**CITY OF CARMEL-BY-THE-SEA  
PLANNING COMMISSION  
SPECIAL MEETING AGENDA**

May 15, 2014  
Thursday  
Tour – 2:00 p.m.  
Meeting – 4:00 p.m.

Planning Commission Report

TOPOGRAPHIC SURVEY  
PLOT PLAN, NOTES

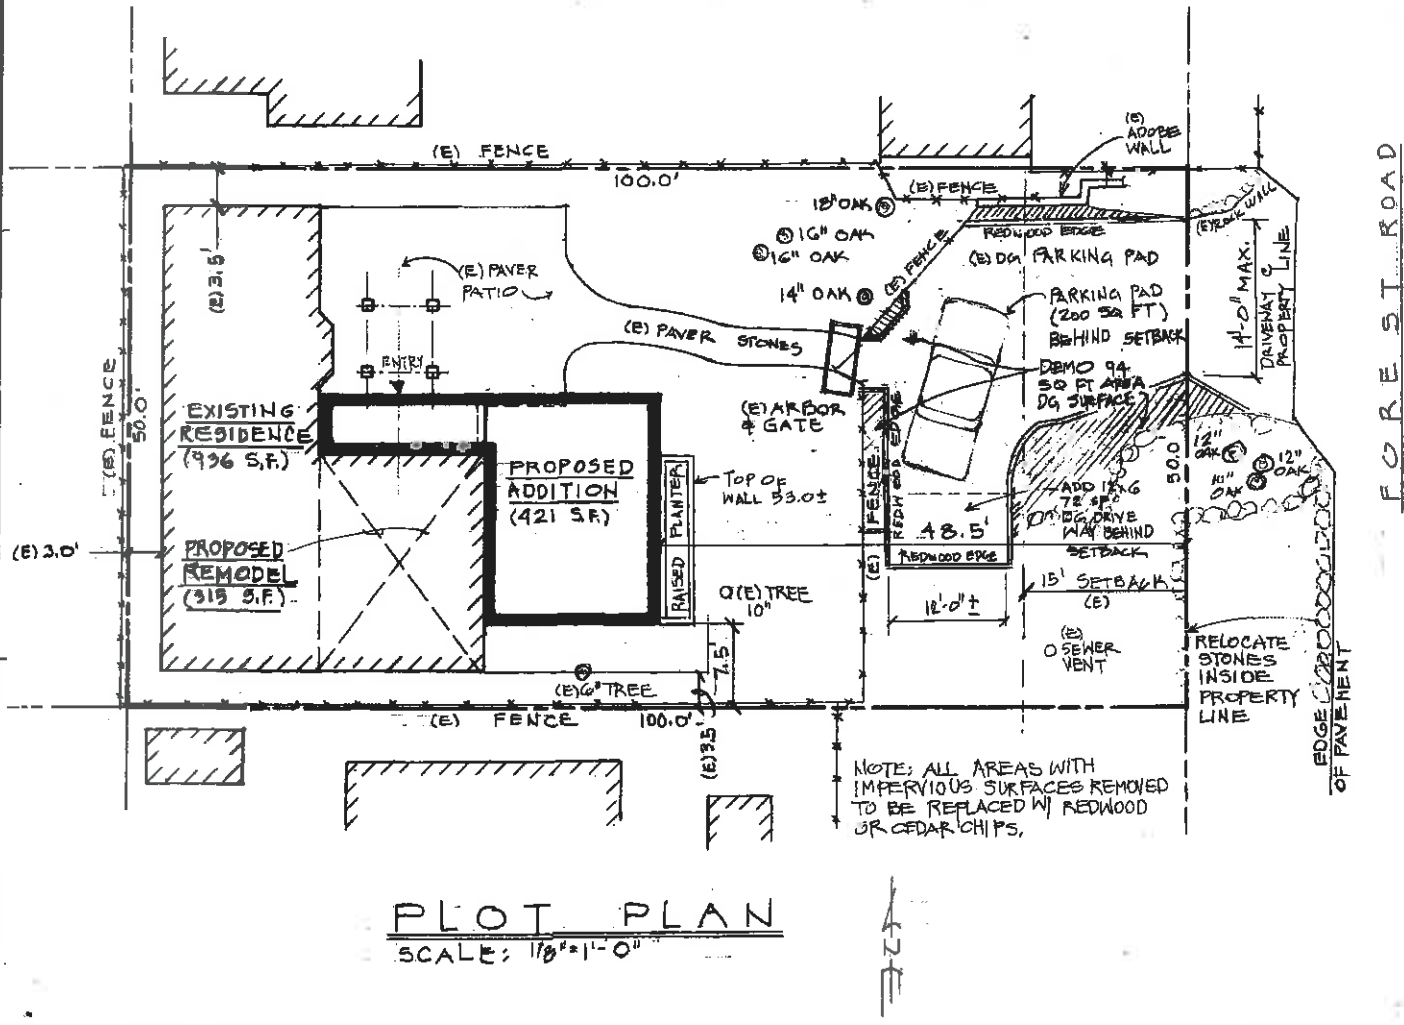
- 4. Prior to final building inspection, the applicant shall remove the existing rocks located in the City ROW as indicated on the project plans. The rocks shall be noted as proposed for removal on the site and landscape plans submitted for final Planning Commission review.*

***Analysis:*** The plans include a note that a portion of the rocks located in the City Row will be relocated to the property line. The site plan also shows rocks located near the northeast corner of property, but there is no note that the rocks will be removed.

A condition has been drafted requiring the applicant to remove all rocks from the City ROW at the front of the property prior to the issuance of the final building inspection. The condition also requires that plans be submitted prior to the building permit submittal noting that all rocks in the City ROW will be removed, including those located at the northeast corner of the property.

LANDSCAPE PLAN

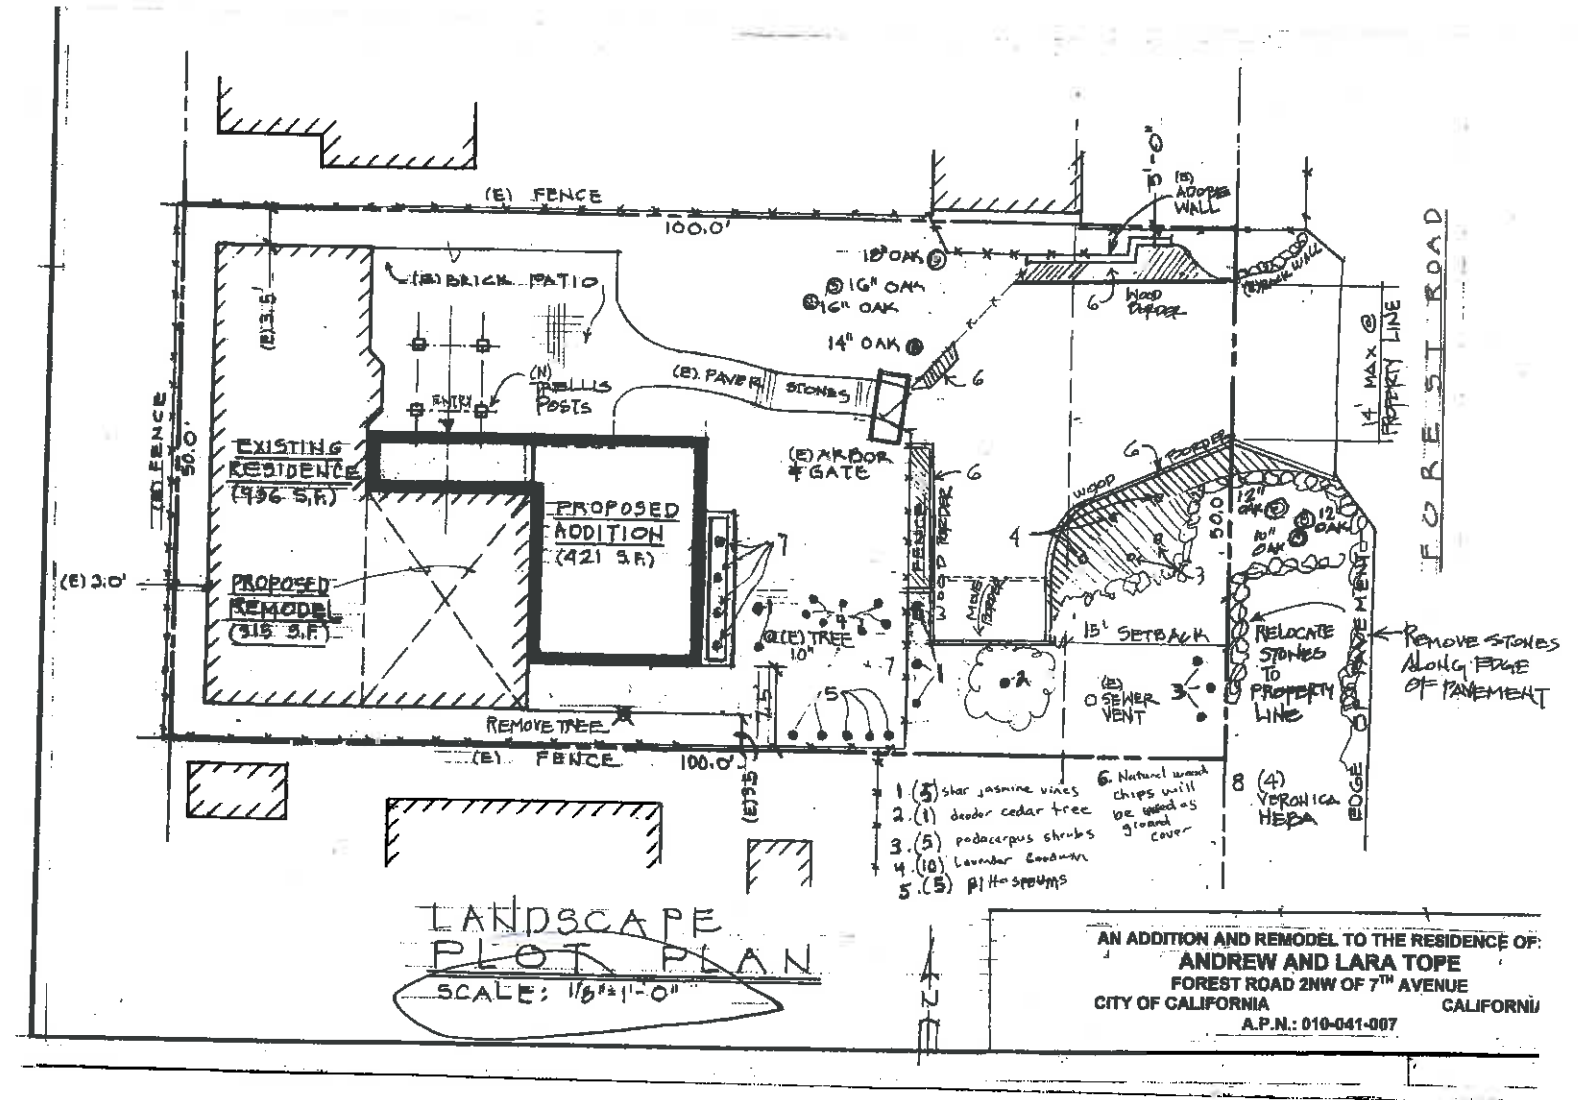
- 3. The applicant shall submit a revised landscape plan that includes additional landscaping at the front of the property and the further reduction of the decomposed granite driveway and parking area at the front of the property for final Planning Commission review. The applicant shall reduce the width of the driveway to 14 feet and shall consider extending the parking pad to the south by a few feet to better organize the parking.*

***Analysis:*** The applicant has revised the project plans to comply with this condition. The parking pad has been shifted farther south to allow for better access, the width of the driveway was reduced to 14 feet, and additional landscaping is proposed at the front of the property. The new landscaping would be consistent with the existing landscaping recently planted by the applicant, as shown in Attachment A.

23.	The applicant shall submit a revised landscape plan to include a scale-bar prior to building permit submittal.

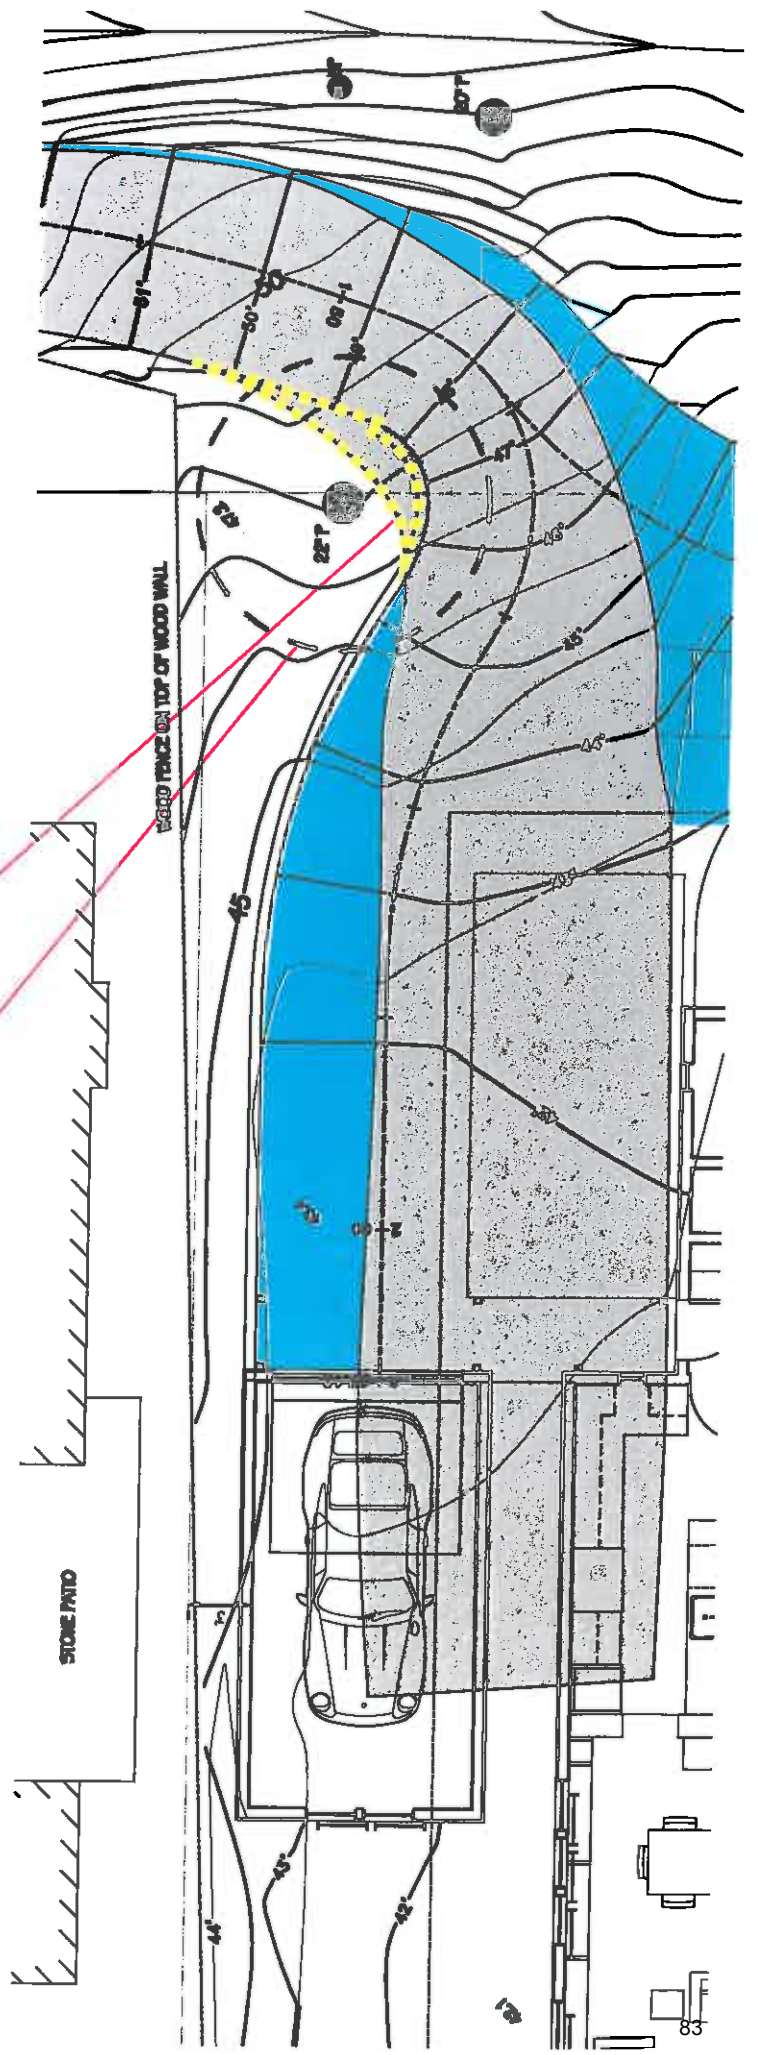
**Condition 4:** No cut or fill is intended for the buffer zones surround trees 2, 3, 5 & 6. Only 6" of cut will occur surrounding pine tree #1 as shown on civil sheet C1, driveway section A. In fact, the proposed driveway design removes almost 3 feet of asphalt that impedes the existing buffer zone at the tree and includes the addition of a short block wall to protect the base of the trunk from traffic. I have attached an exhibit, Attachment 1, which shows the area of asphalt to be removed. Also, see Planting Note #4 on the landscape plan regarding the treatment of areas around major tree roots.

Remove existing portion of driveway at pine tree

6 foot buffer zone at existing pine tree. Carefully hand dig if required by arborist.

**A3.2**

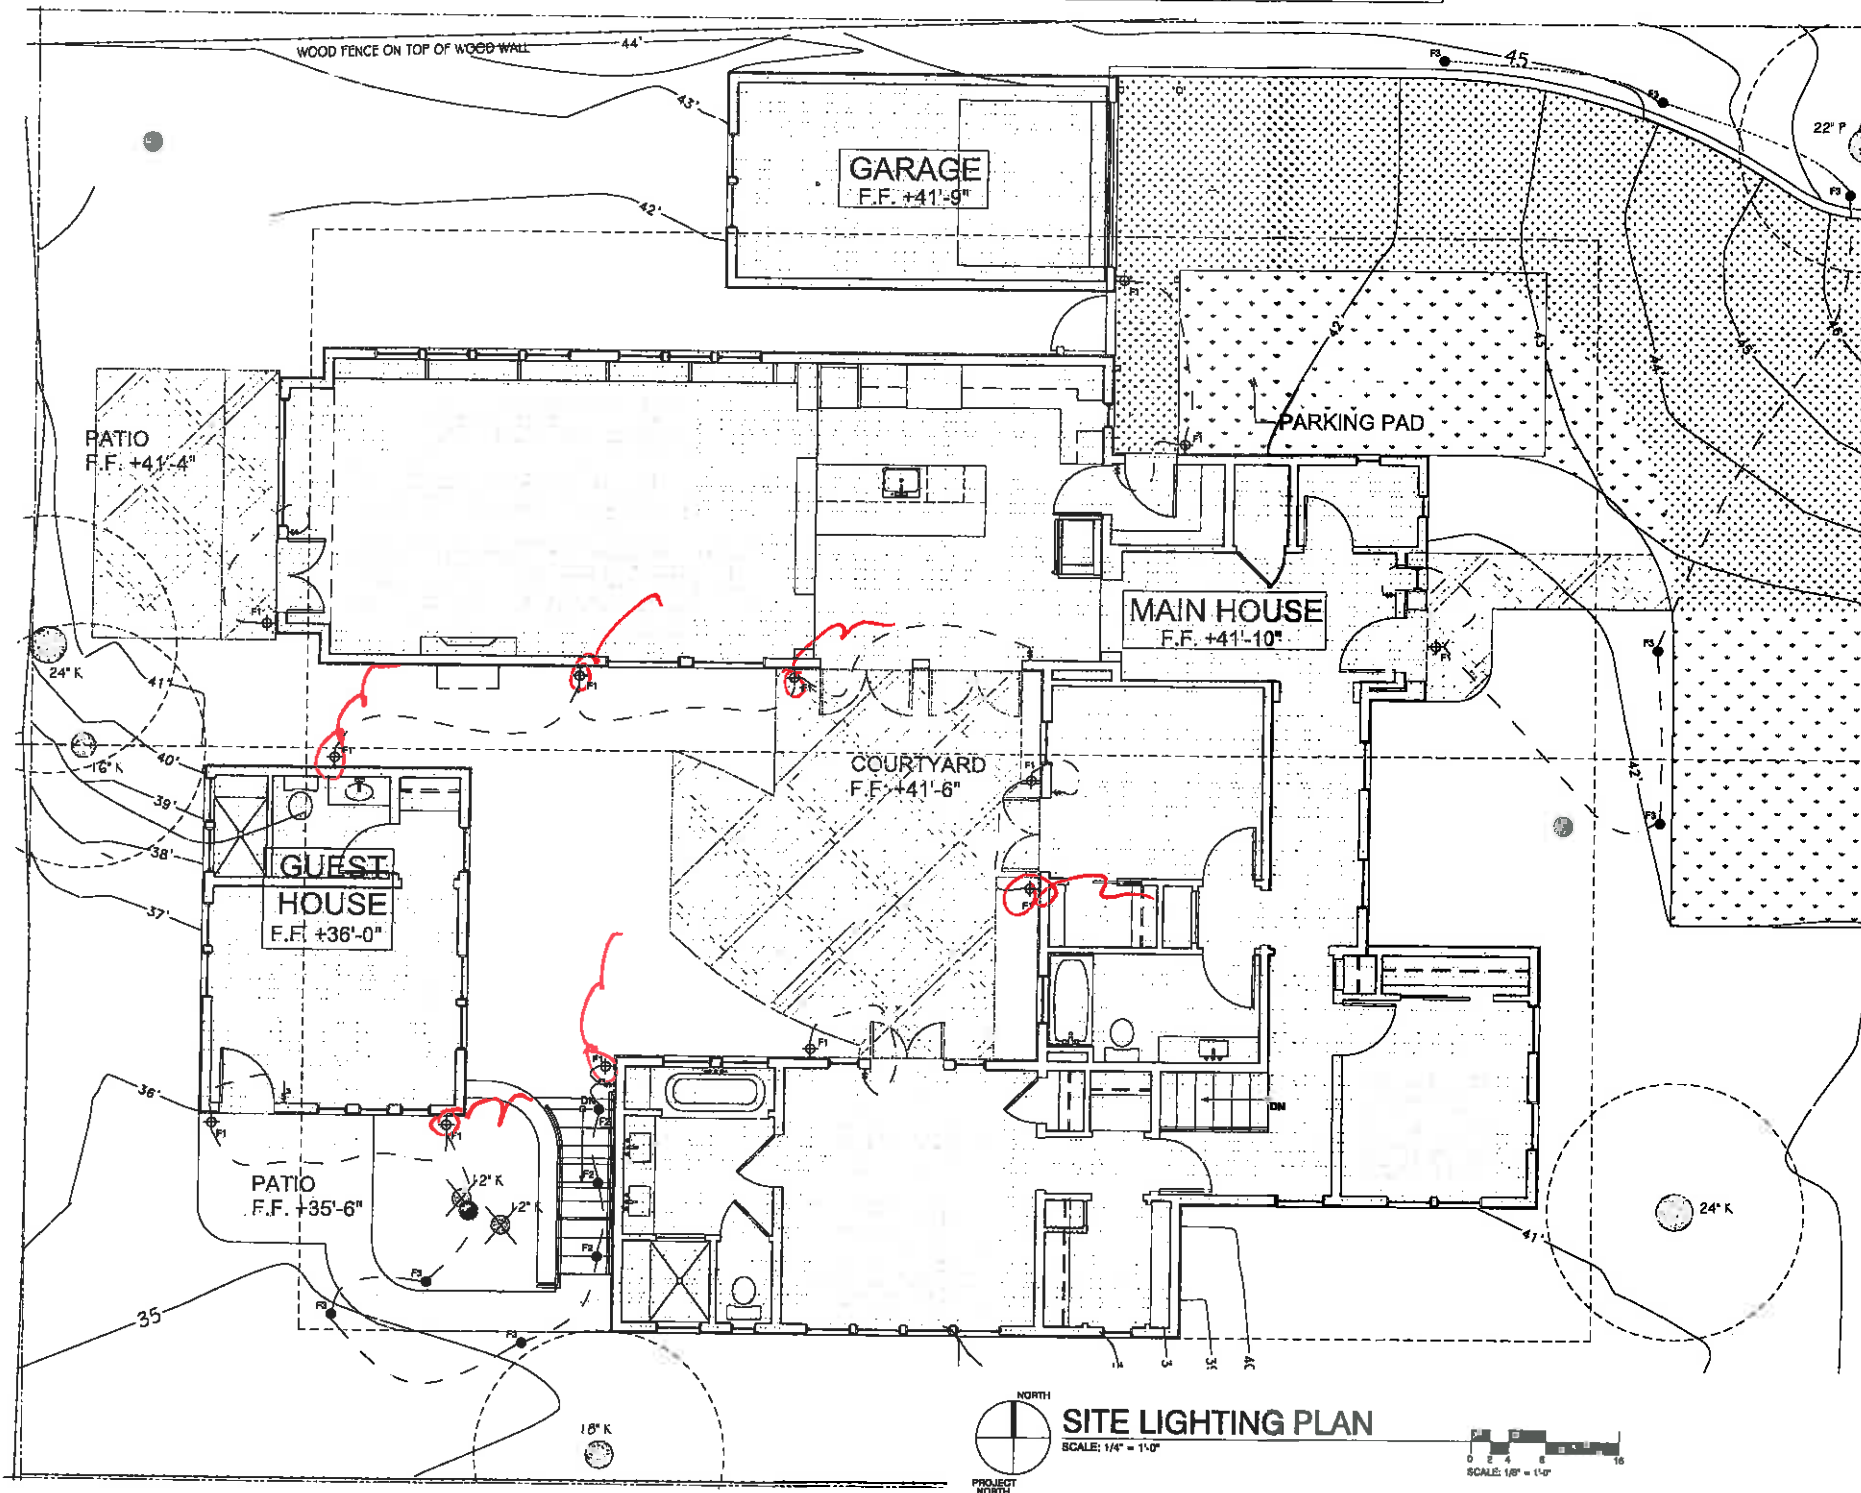
Condition 8: See revised sheet A3.2 for an expanded street level view that includes more of the neighboring structures.
